Objection submission COM/2019/81 -

Nucrush Quarry Key Resource Area 68 (KRA68) has been compromised

Attachment A3 - 'Plan 362-010' showing prohibited development areas: 'Buffer Land' and 'Permanent Tree and shrub screening' areas

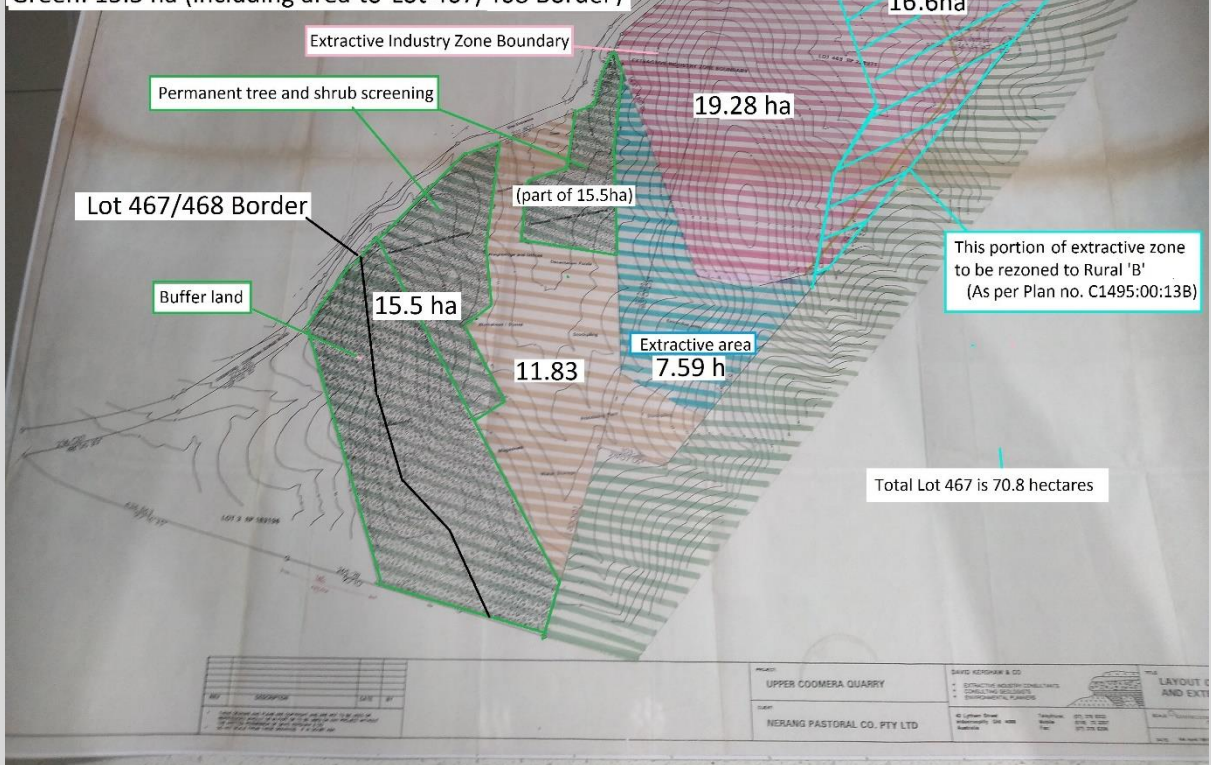
This, I believe cannot, be used by the applicant and the City Planner's to ignore the established prohibited development areas for the life of the quarry e.g. *'Buffer Land', 'Permanent Trees and shrub screening'* areas as shown in the *'Third Schedule'* and/or *'Plan 362-010'* of Rezoning agreement (Attachment A3), and prohibited development area known as Rural 'B', as shown in *'Plan C1495:00:13B'* (Attachment A4). That were all put in place at the quarry's inception for very good reasons i.e. to protect local residents from quarry encroachment and to protect the quarry from urban encroachment. In no way can *"Identifying the amended resource / processing area for KRA68*

Plan 362-010 (Third Schedule of Rezoning Agreement)
 Red: Extractive 19.28 ha approx (excl Rural 'B' 16.6ha)
 Blue: Extractive Area 7.59 hectares
 Yellow: 11.83 ha (Ancillary operations)
 Green: 15.5 ha (including area to Lot 467/468 Border)

Note: Extraction prohibited in 2.1 ha of red area (40m buffer required to tamborine -Oxenford Road) and 1 ha extraction prohibited in blue area (40m buffer required from Lot 906).

Total extractive footprint is 23.77 ha $(19.28 - 2.1) + (7.59 - 1)$ NOT the claimed 56.02 ha

Attachment E11 - Sherman Drive, Upper Comara looking east to quarry

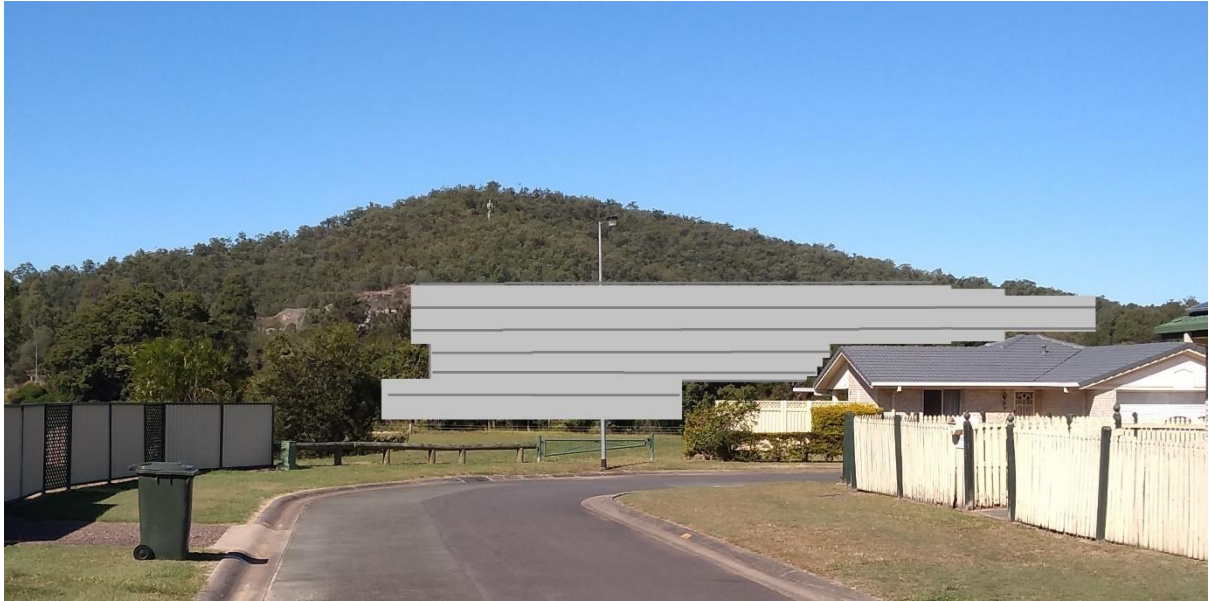
In the west, there will be no topographic features (no ridge, etc.) preventing an unbroken view into the inner workings of the quarry for homes such as residents of ‘Sherman Drive, Upper Coomera’ (Attachment E10). The believed extent of the proposed benching and exposed faces and inner quarry workings (including the February 2021 extractive footprint modification) are reproduced in attachment E11. The extractive footprint at this location will be within 365 metres approx of homes in Sherman Drive. This is obviously a long way short of the 1000 metres separation buffer required and there are no topographical reasons that I can see that can be attributed to this scything of the separation buffer to nearly a third or the distance required.

The believed extent of the affected view when the proposed expansion is progressing

Attachment F7 - State Controlled Road - Boral Stapleton (KRA69)

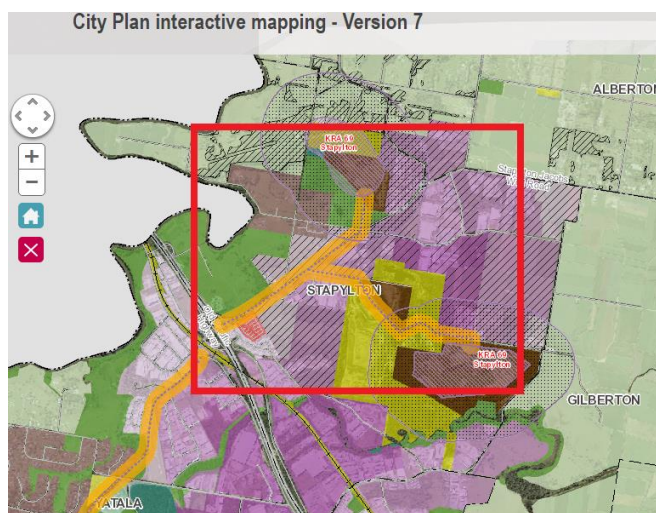
To be crystal clear, the fact that the Tamborine-Oxenford road is a State owned road has no bearing on whether it is a Transport route or not as is clearly demonstrated in Attachment F7 showing the Boral, Stapylton Quarry (KRA69) transport route that is via a state controlled road to the Pacific Motorway (as shown in Attachment F8). Attachment F9 demonstrates the Oxenford quarry is accessed from the Pacific Highway in the same manner as the Stapylton quarry yet the City Plan has failed to show the required Transport Route correctly for the Oxenford Quarry, KRA68.
